78 Bridge Street RFP- Questions Recieved:

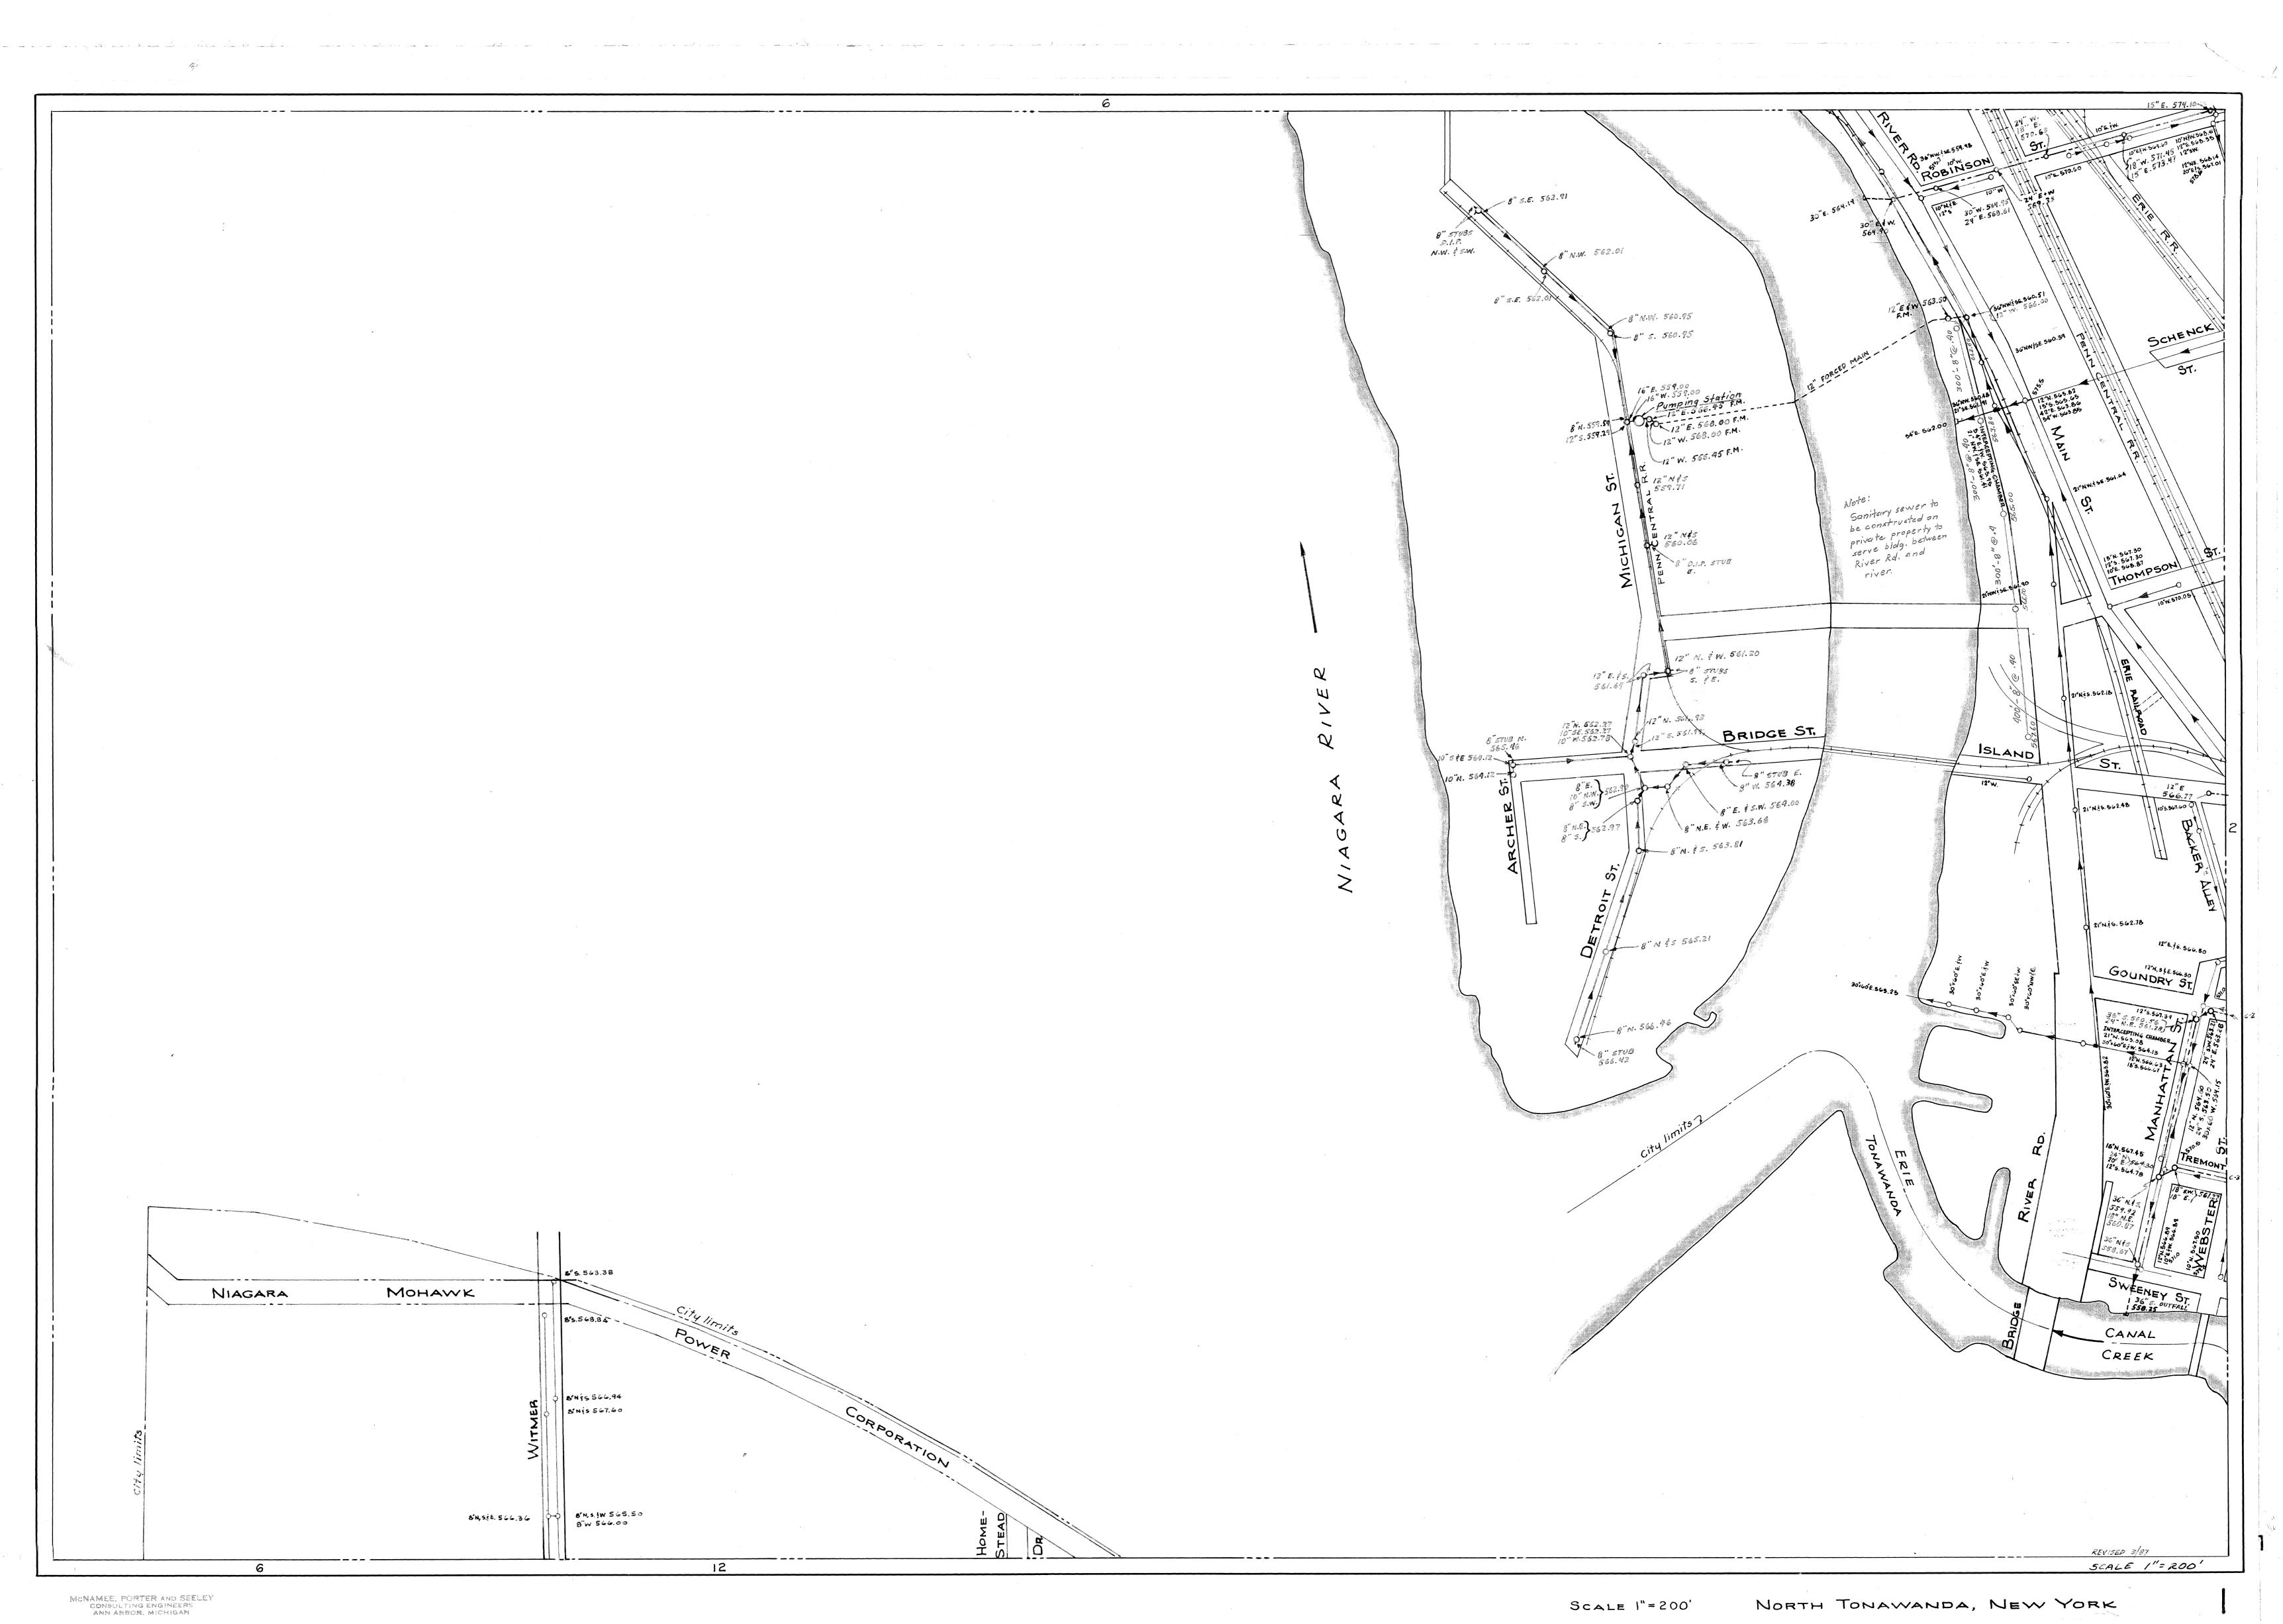
- Are you able to provide the location of the nearest sewer pump located that the property would be able to tie into? Attached. Solid lines are the island is the sanitary sewer. There are no storm sewers on the Island. Everything is gravity to the pump station on Michigan Ave. where it is then pumped to the main land via forcemain to the gravity system along River Road.
